UNITED STATES PATENT AND TRADEMARK OFFICE

Office Action Summary	Application No.	Applicant(s)	
	10/583,150	EOM ET AL.	
	Examiner	Art Unit	
	MICHAEL SCHAPER	3775

DETAILED ACTION

FIG. 4

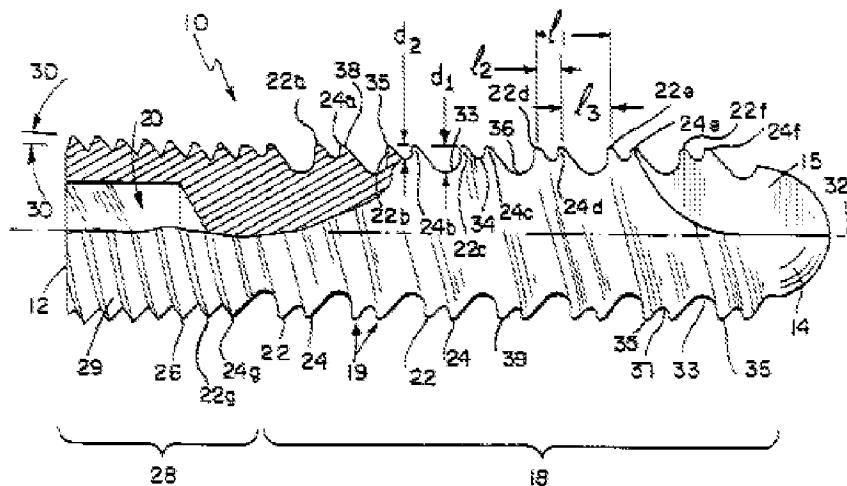
Claims 2-3 are rejected under 35 U.S.C. 102(b) as being anticipated by Bono et al. (US 6129730).

Bono discloses a fixture (FIG. 4) with an uppermost part (28) and body part (18), the body part comprising a cortical bone coupling part (length along 22a-d, 24a-d), cancellous bone coupling part (length along 22e-f, 24e-f), large cancellous screw threads (22e-f, 24e-f), large cortical screw threads (22a-d, 24a-d), small cancellous screw threads (recesses within 22e-f, 24e-f), small cortical screw threads (recesses within 22a-d, 24a-d), wherein there are more small cortical screw threads than small cancellous screw threads (see FIG. 4); wherein the respective leads of the large cortical

and cancellous screw threads are equal (col. 3 / lines 16-28); wherein the root diameter of the cancellous bone coupling part is constant (see FIG. 4).

FIG. 4

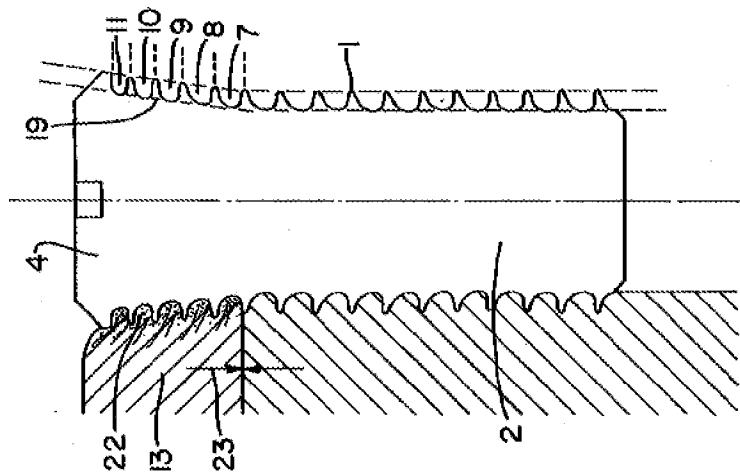
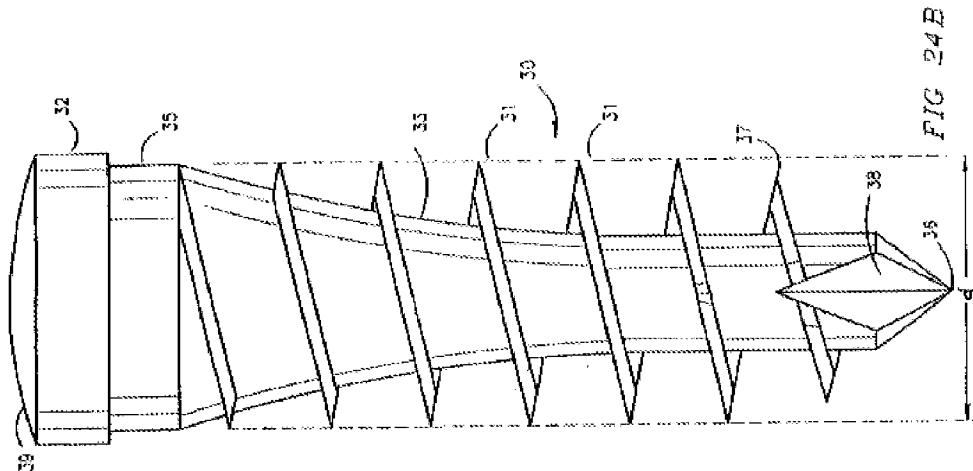
Claim 1 is rejected under 35 U.S.C. 103(a) as being unpatentable over Bono et al. (US 6129730) in view of Mathys (US 5403136).

Bono discloses a fixture (FIG. 4) with an uppermost part (28) and body part (18), the body part comprising a cortical bone coupling part (length along 22a-d, 24a-d), cancellous bone coupling part (length along 22e-f, 24e-f), large cancellous screw threads (22e-f, 24e-f), large cortical screw threads (22a-d, 24a-d), small cancellous

screw threads (recesses within 22e-f, 24e-f), small cortical screw threads (recesses within 22a-d, 24a-d).

Bono discloses the claimed invention except for small cortical screw thread having a pitch, a root diameter, and an outer diameter almost equal to a pitch, a root diameter, and an outer diameter of the small cancellous screw thread.

Mathys discloses a fixture (FIG. 4) wherein cortical screw thread has a pitch, a root diameter, and an outer diameter almost equal to a pitch, a root diameter, and an outer diameter of the small cancellous screw thread (col. 3 / lines 13-20) for the creation of locally differentiated intraosseous pressure.

At the time of invention, it would have been obvious to a person of ordinary skill in the art to have modified Bono with a fixture wherein cortical screw thread has a pitch, a root diameter, and an outer diameter almost equal to a pitch, a root diameter, and an outer diameter of the small cancellous screw thread in view of Mathys for the creation of locally differentiated intraosseous pressure.

Fig. 5

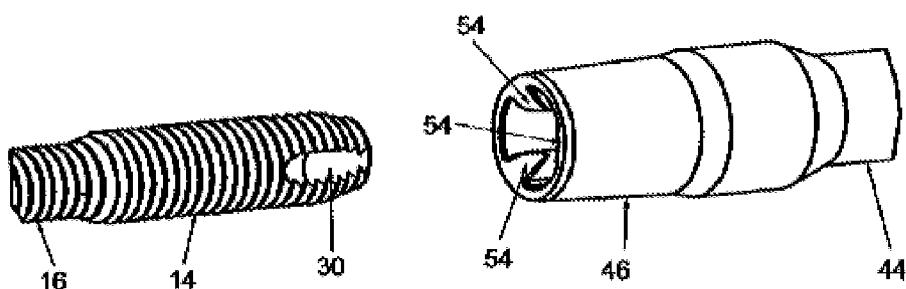
Claim 6 is rejected under 35 U.S.C. 103(a) as being unpatentable over Bono et al. (US 6129730) in view of Mathys (US 5403136) further in view of Taras et al. (US 2003/0158556).

Bono in view of Mathys disclose the claimed invention except for longitudinal grooves formed in a circumferential outer surface of the cortical bone coupling part.

Taras discloses a fixture with longitudinal grooves formed in a circumferential outer surface of the cortical bone coupling part (30, FIGS. 1&5, [0034]) for providing means for engaging the screw for removal.

At the time of invention, it would have been obvious to a person of ordinary skill in the art to have modified Bono in view of Mathys with a fixture with longitudinal grooves formed in a circumferential outer surface of the cortical bone coupling part in view of Taras for providing means for engaging the screw during removal.
